THM 4L60-E/4L65-E "UPDATE HANDBOOK"

AUTOMATIC TRANSMISSION SERVICE GROUP

THM 4L60-E/4L65-E

**1997 13-VANE PUMP COVER
IDENTIFICATION**

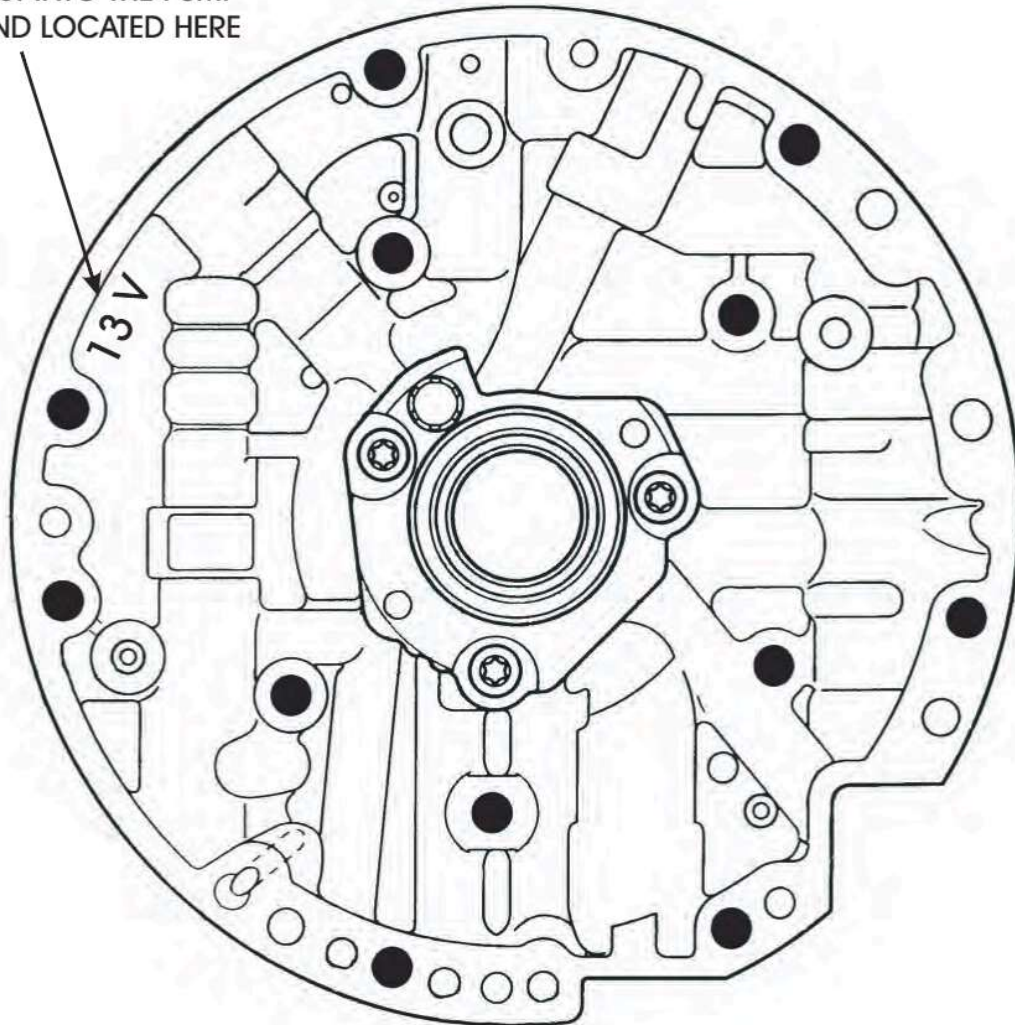
***THIS PUMP COVER WILL NOT INTERCHANGE WITH PREVIOUS MODELS.
IT MUST BE USED WITH THE 13 VANE ROTOR AND SLIDE.***

Figure 1

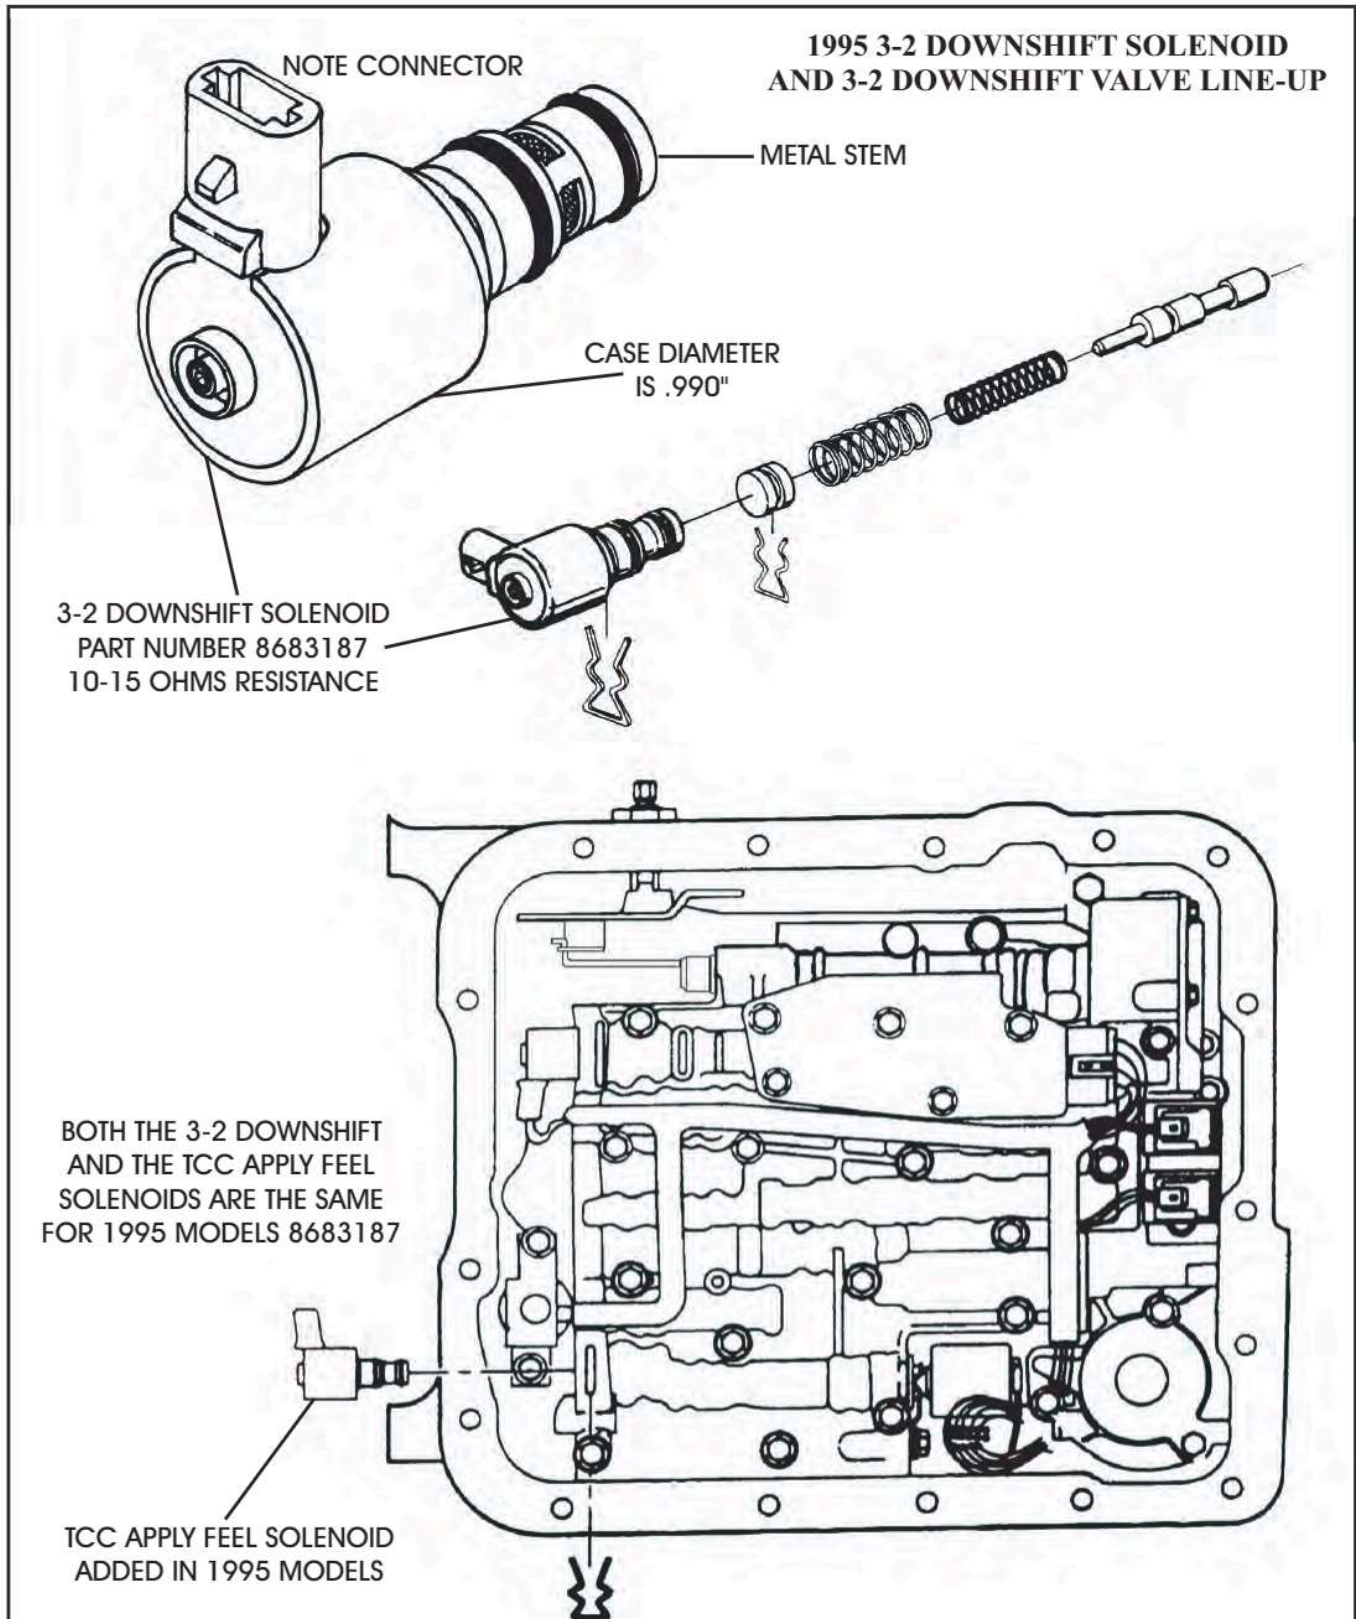
- (1) 3-2 DOWNSHIFT SOLENOID - Changes from a Pulse Width Modulated (PWM) solenoid to a regular "On-Off" (Normally Open) solenoid, which also requires a different Powertrain Control Module (PCM). The new design "On-Off" 3-2 downshift solenoid can be identified by the case diameter, which is smaller than the previous design, and the new design solenoid also has a *plastic* stem that fits into the valve body bore, where the previous design was *metal*. The solenoid connector was also changed to prevent the solenoids from being accidentally installed in the wrong models. Refer to Figure 1 for 1995 models, and Figure 2 for 1996 models.

- (2) 3-2 DOWNSHIFT VALVE - The entire 3-2 downshift valve line-up changes to accommodate the new design "On-Off" 3-2 downshift solenoid. Refer to Figure 1 for 1995 models, and Figure 2 for 1996 models.

3-2 DOWNSHIFT SOLENOID AND TCC/PWM SOLENOID CHANGES

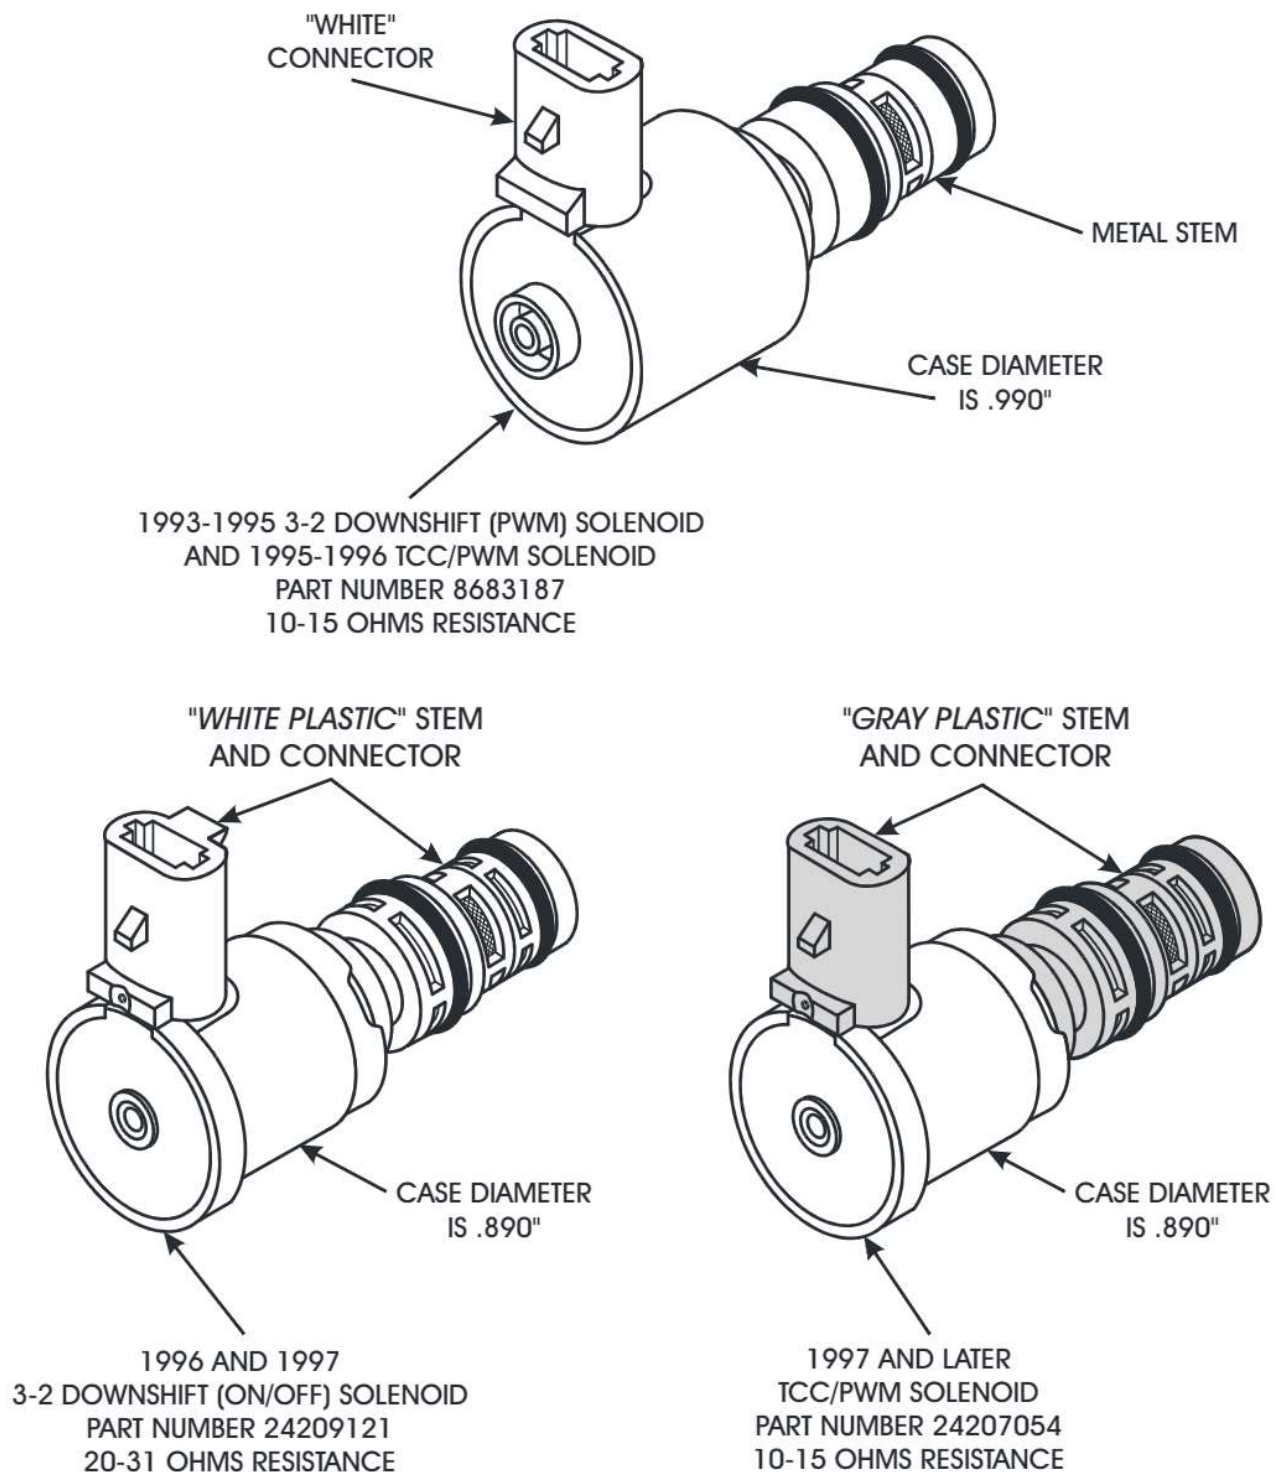
- (1) TCC/PWM SOLENOID - Changes from a metal stem to a "Gray Plastic" stem as shown in Figure 1, and the solenoid connector is also Gray in color to help distinguish it from the 3-2 Downshift (ON-OFF) Solenoid. These two solenoids are now manufactured identical, with the exact same dimensions, except for the difference in color of the solenoid stem and solenoid connector. The wide groove to accept the internal harness connector is also on opposite sides of the solenoid connector to prevent the solenoids from being accidentally installed in the wrong models, as shown in Figure 1.

**NEW ELECTRONIC PRESSURE CONTROL SOLENOID
PART NUMBER 24209276**

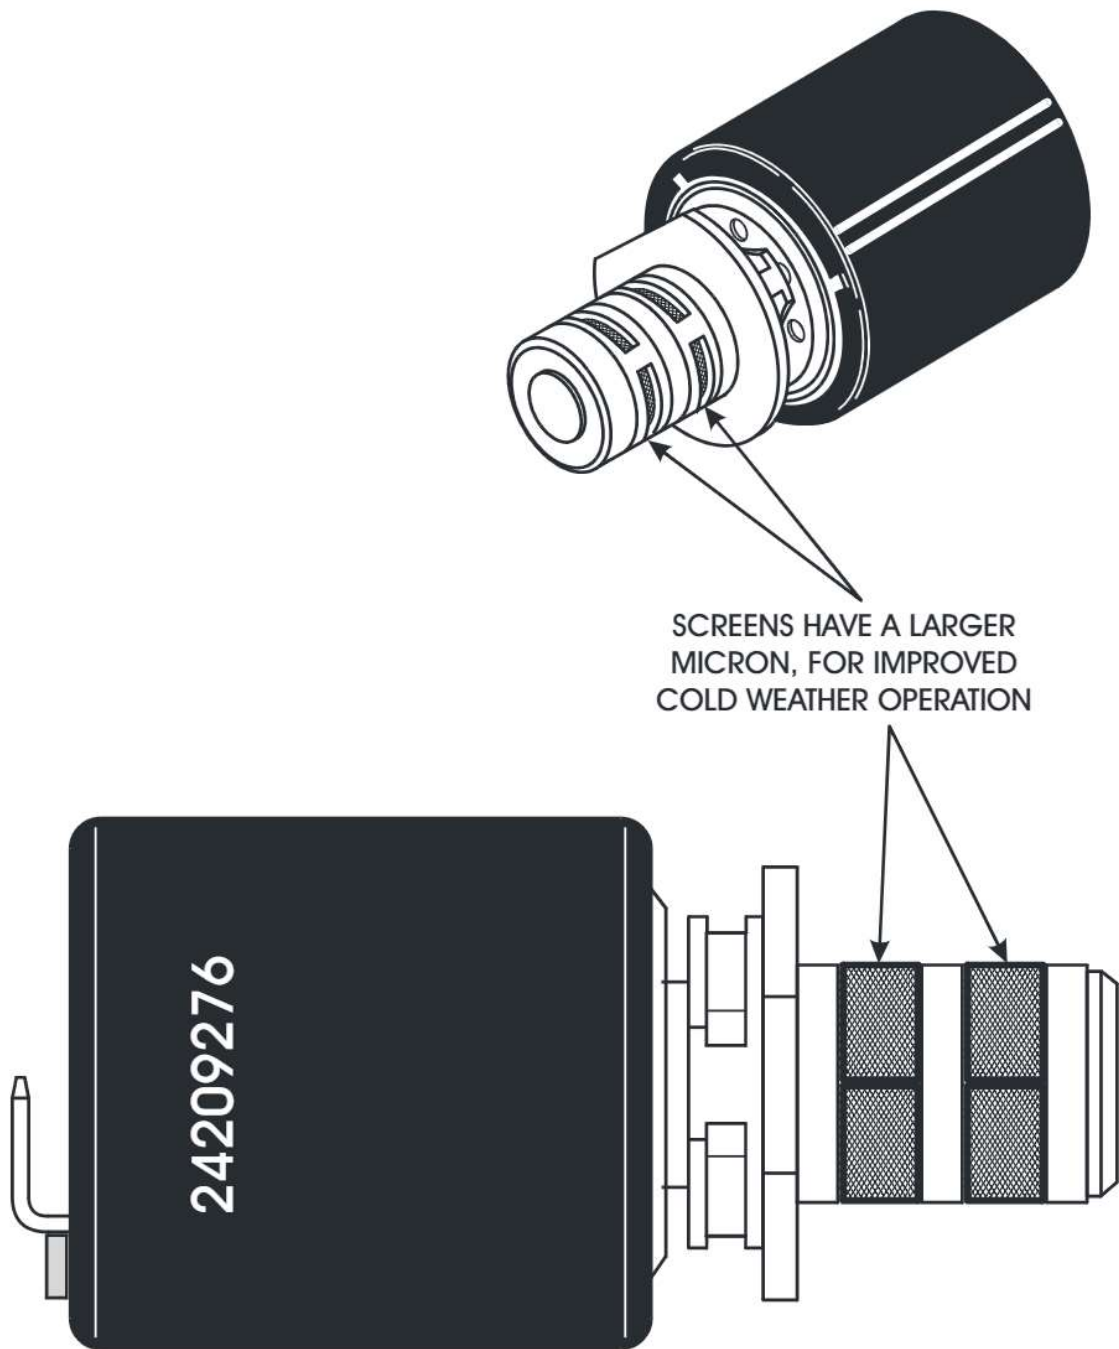
- (3) PRESSURE CONTROL SOLENOID - New design has larger micron screens in the solenoid to greatly improve cold weather operation. This will allow the colder oil through the screens easier. Refer to Figure 3.

Figure 1

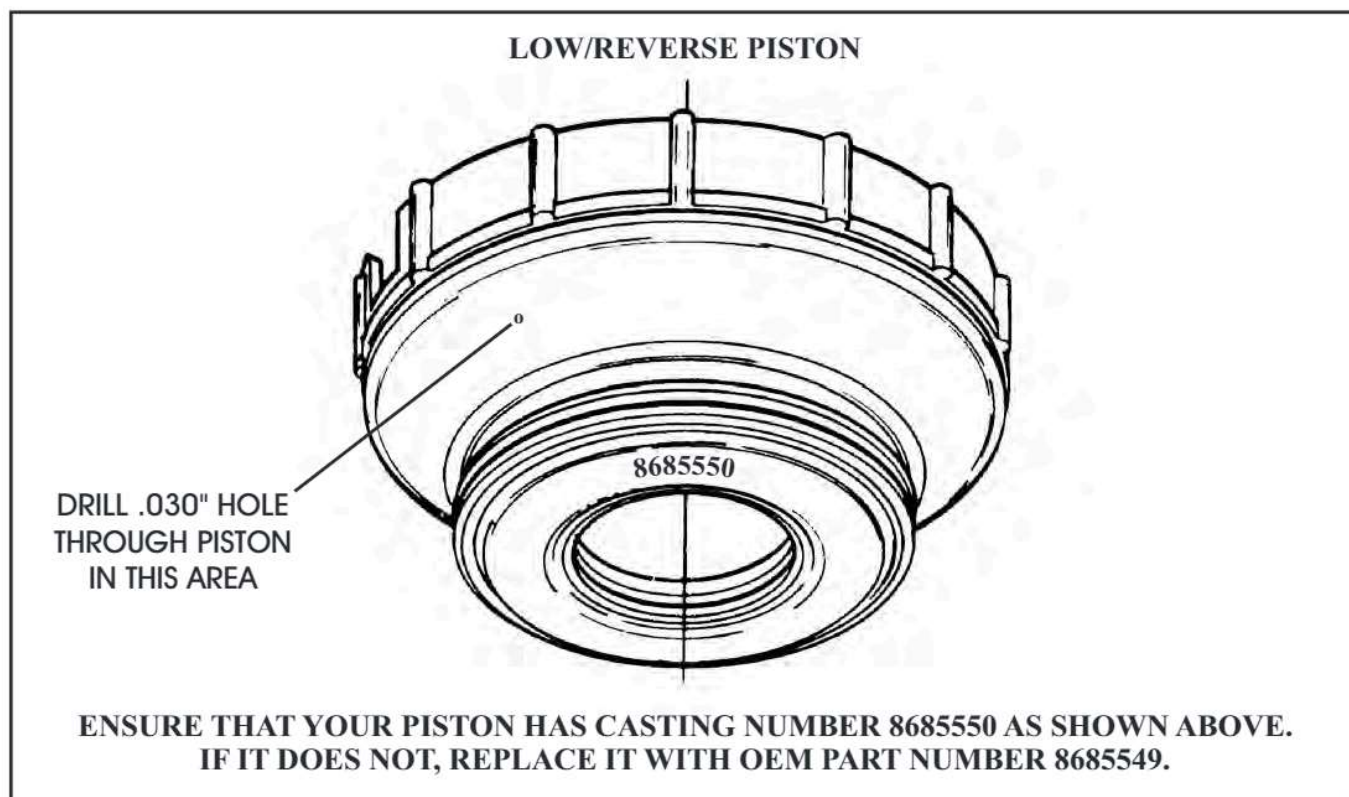
CORRECTION: STEP 1: Drill a .030" hole through the Low/Reverse Piston, in the tapered area between the outer seal and the center seal, as shown in Figure 1. This will provide an immediate exhaust path for PR apply oil when the selector lever is placed into the Drive position.

1995 MANUAL VALVE AND VALVE BODY CASTING

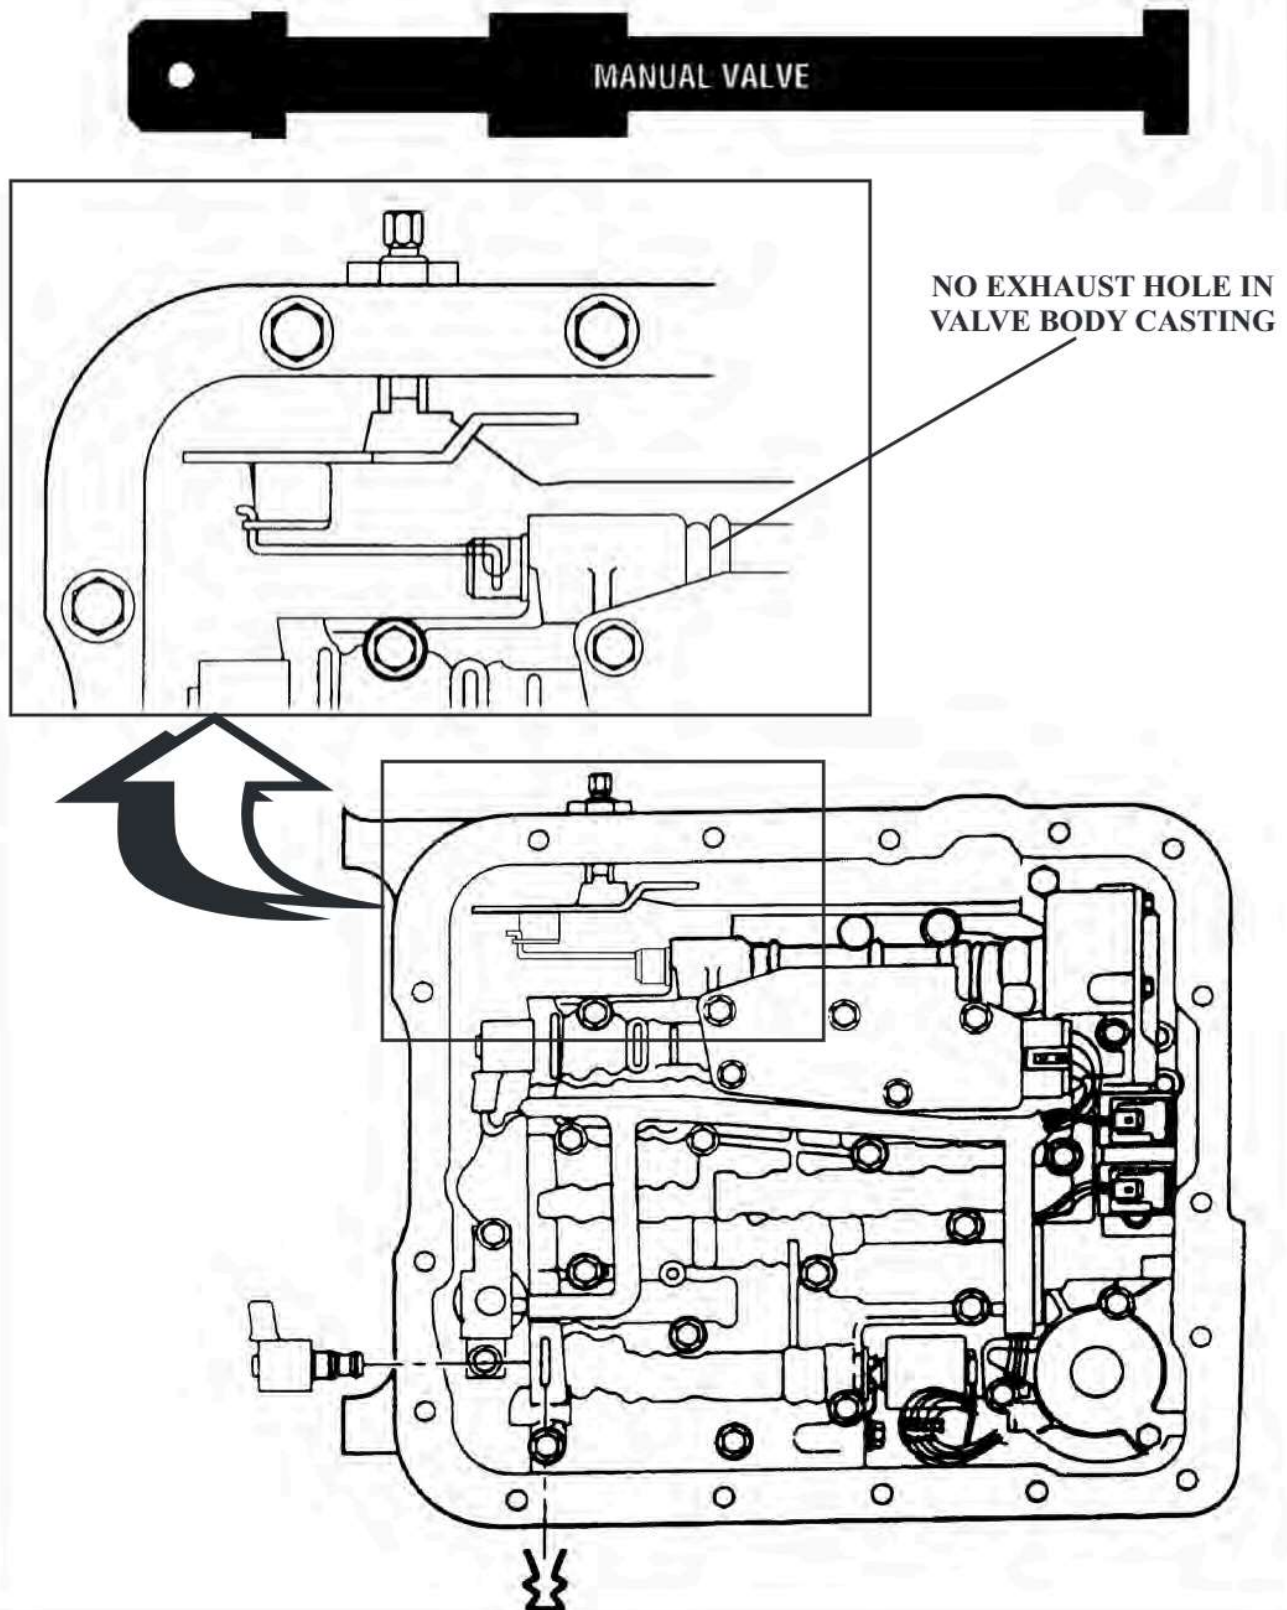
- (1) **VALVE BODY CASTING** - Added exhaust hole through the valve body casting in the manual valve bore, to exhaust Lo/Reverse clutch oil at a faster rate when the manual valve is in the Drive position. Refer to Figure 1 for 1995 models, and to Figure 2 for 1996 models.
- (2) **MANUAL VALVE** - Totally different design to accommodate the added exhaust hole in the valve body casting. Refer to Figure 1 for 1995 models, and to Figure 2 for 1996 models.
